Access Compliance Report

Public Rights-of-Way

Intersection ID: 31492	Main Street: CLOVER_GAP_DR	Cross Street: JORDANS_POND_LN	Location: E
ADA ID: 88CBC00F58E5	Ramp Type: PerpDiag	Initial Pass/Fail: Fail	Overall Compliance: No
Severity Score: 8.75			
Codes/Mitigation Info/Possible Solution		Field Measurements/Component Compliance

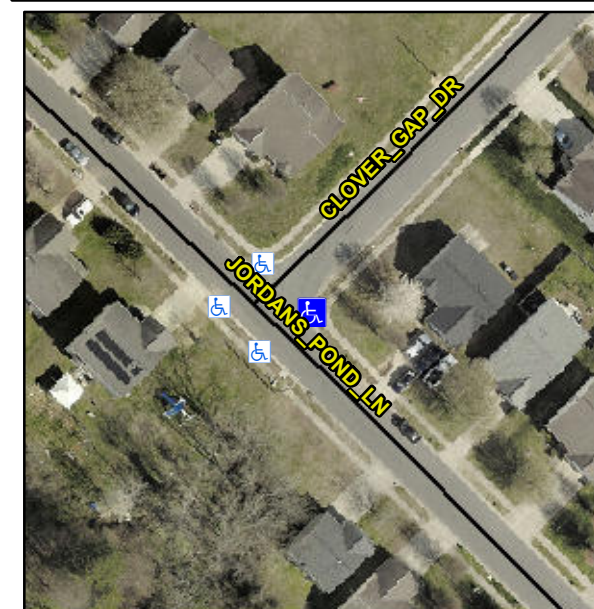
Not Found, R304.5.1

Compliance	Description	Data	Compliance	Description	Data
N/A	Ramp Length (in)	49.0	Yes	Ramp Slope (%)	5.3
No	Ramp Width (in)	44.0	Yes	Ramp XSlope (%)	0.4
N/A	Flare Type LT	N/A	N/A	Flare Type RT	N/A
N/A	Flare Slope LT (%)	N/A	N/A	Flare Slope RT (%)	N/A
N/A	Flare Traversable LT?	N/A	N/A	Flare Traversable RT?	N/A
N/A	Landing Length (in)	N/A	N/A	DWS Provided?	N/A
N/A	Landing Width (in)	N/A	N/A	DWS Contrast?	N/A
N/A	Landing Slope (%)	N/A	N/A	DWS Length (in)	N/A
N/A	Landing X Slope (%)	N/A	N/A	DWS Full Width?	N/A
N/A	Landing Curb? (Y/N)	N/A	N/A	DWS Offset (in)	N/A
N/A	Shared Landing?	N/A			
N/A	Gutter Ponding?	N/A	N/A	Gutter Slope (%)	N/A
N/A	Gutter Lip Ht (in)	N/A	N/A	Gutter X Slope (%)	N/A
N/A	Painted X Walk1?	No	N/A	Painted X Walk2?	No
	X Walk 1 Direction	To NW		X Walk 2 Direction	To SW
N/A	X Walk 1 Width (in)	N/A	N/A	X Walk 2 Width (in)	N/A
	X Walk 1 Slope (%)	0.4		X Walk 2 Slope (%)	0.9
	X Walk 1 X Slope (%)	0.4		X Walk 2 X Slope (%)	1.1

Remove & Replace Curb Ramp With Two New Directional Ramps or Equivalent.
